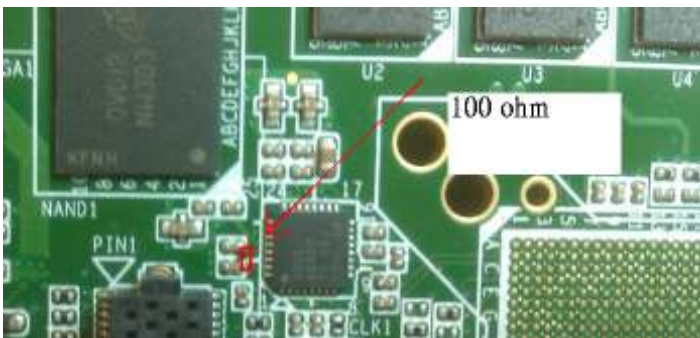
1. Fold the middle pin of power jack and move the power jack to backside to avoid the interference with AMC golden finger

2. Move the COM1 to backside and adopt a 90 degree connector to avoid the interference with XDS560V2 mezzanine card.

3. The CDCE62002 do not have built in 100-ohm terminations, so add a 100-ohm resistor across the CLK1 sides of the C46 and C51 for REFCKP/N inputs to CLK1 (DDR3 reference clock)

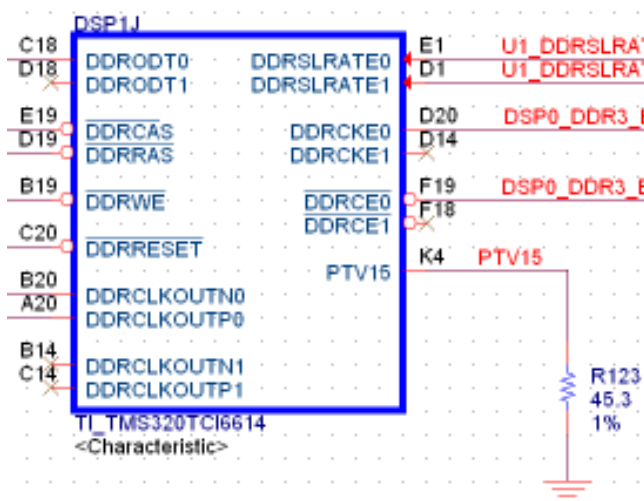
4. Change the value of R123 to 45.3 ohm

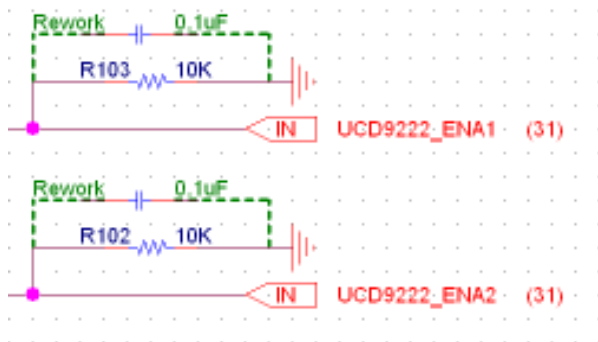
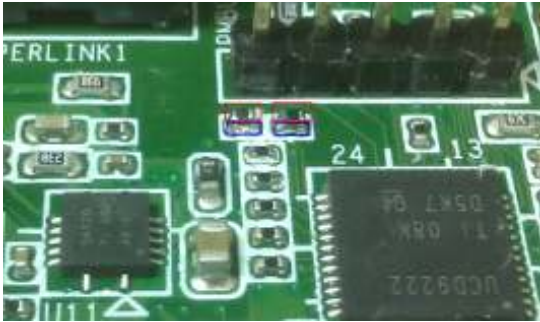
- Due to the UCD74106 unstable issue, parallel the 0.1uF capacitor at R102 and R103 to filter the noise on UCD9222_ENA1 and UCD9222_ENA2

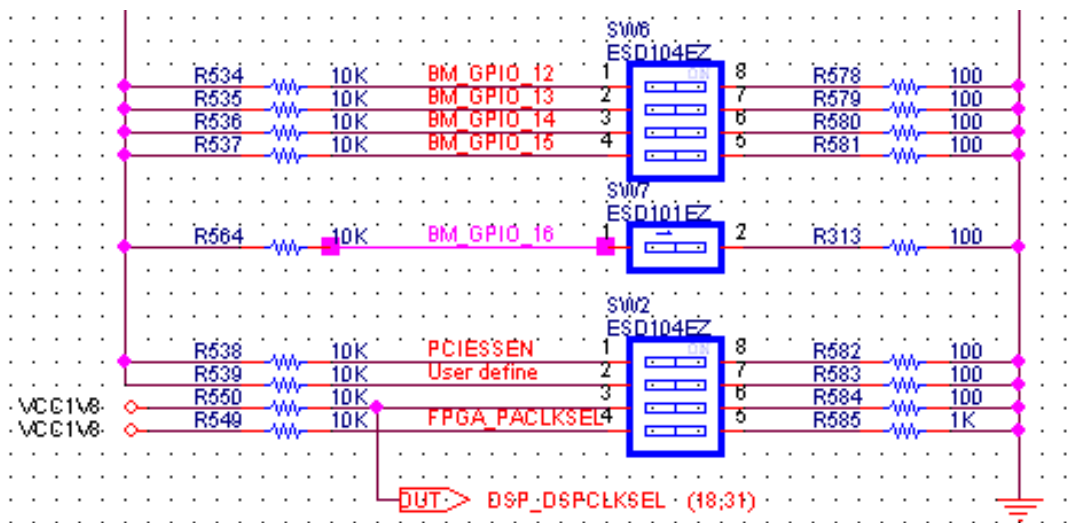
- BM_GPIO_16 is not connected to FPGA, and so we make a workaround on FPGA code to control GPIO16 with SW2(user define pin)

- The footprint of OSC1(VCTCXO) are too small to assembly on PCB. We will measure the clock signal after SMT to assure the functionality.
